Date 10/10/2022
To Daniel Blair (Hi-Quality Group)
From Melanie Gostelow (Arcadis)
Copy to Claire Hodgson (Arcadis), Samantha Oyston (Arcadis)
Subject Prestons Waste Treatment Facility – Additional Flooding Assessment

Re: EXHIBITION OF STATE SIGNIFICANT DEVELOPMENT APPLICATION SSD-9346594

PROPOSAL:	LOT 103 DP 866530
ADDRESS:	9 WHYALLA PLACE, PRESTONS NSW 2170

Figure 1: General Flood Hazard Categorisation

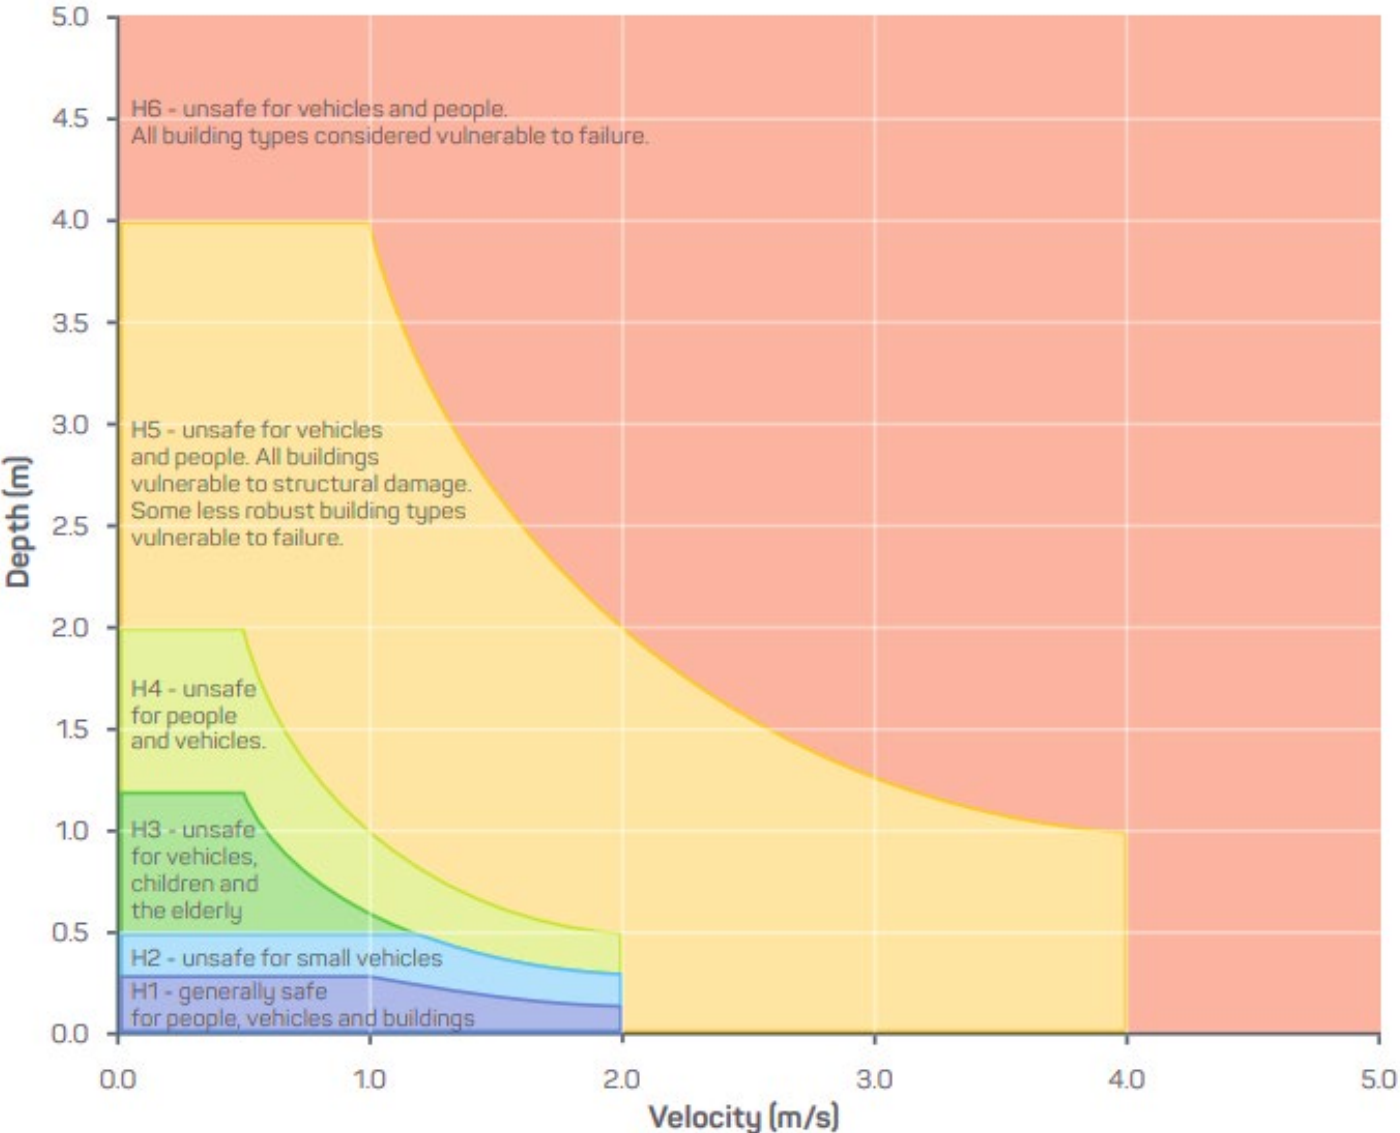
The flood hazard has been defined based on the Australian Institute of Disaster Resilience general flood hazard classification illustrated below in Figure 1. The flood hazard within the Site is typically H3 being unsafe for vehicles, children and the elderly. Under these conditions the Site is considered a low hazard to adults. The flood hazard increases approaching the western Site boundary with Whyalla Place.

Along Whyalla Place the flood hazard increases to H5 which is considered unsafe for vehicles and all people. A shelter-in-place strategy is appropriate for the Site which can be accommodated by the existing second level office space.

Given that within the Site the depth velocity product is less than $1\text{m}^2/\text{s}$, it is considered a low hazard risk to structures. It is recommended that a structural assessment is undertaken to determine the suitability of the existing and proposed fences/ exterior walls given the PMF conditions of the Site.

Title: **Existing Conditions
2 hour Probable Maximum Flood Event - Peak Flood Depths**

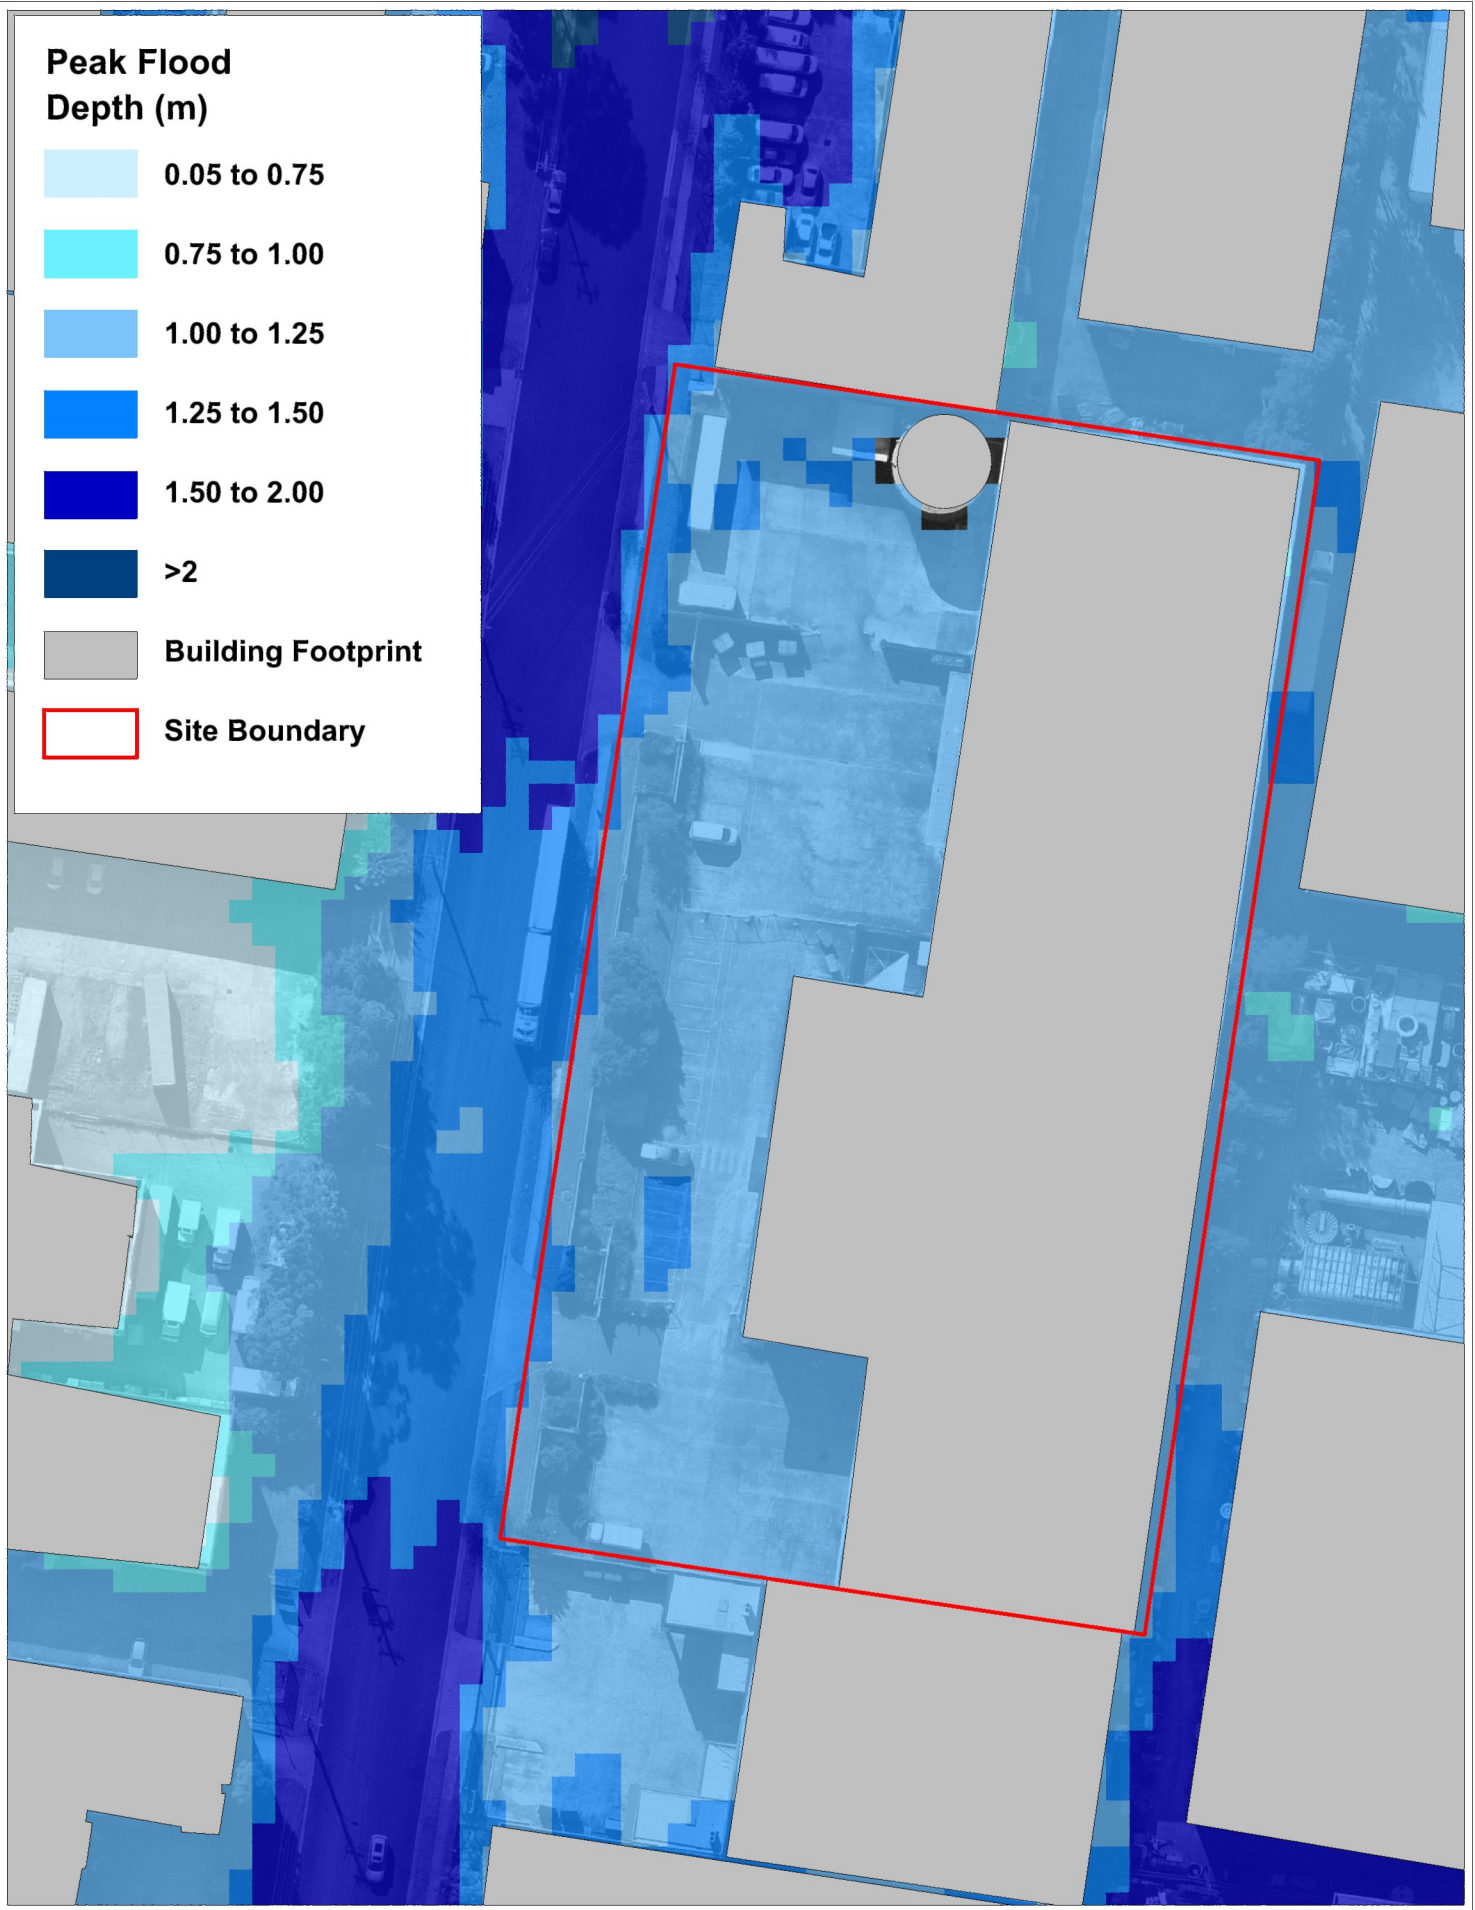
The revised TUFLOW flood model was rerun for the 2 hour PMF flood event to produce additional flood hazard mapping of the Site. The existing and post-development conditions flood mapping has been provided in the attachment as Figures A1 to B2.

During the PMF event an overland flow path forms along Whyalla Place draining to the north. The peak flood depths within the Site are generally 1.00m to 1.25m deep with no significant impact of the proposed redevelopment. Peak flood depths along Whyalla Place are deeper than the Site reaching 1.6m at the northern boundary of the Site.
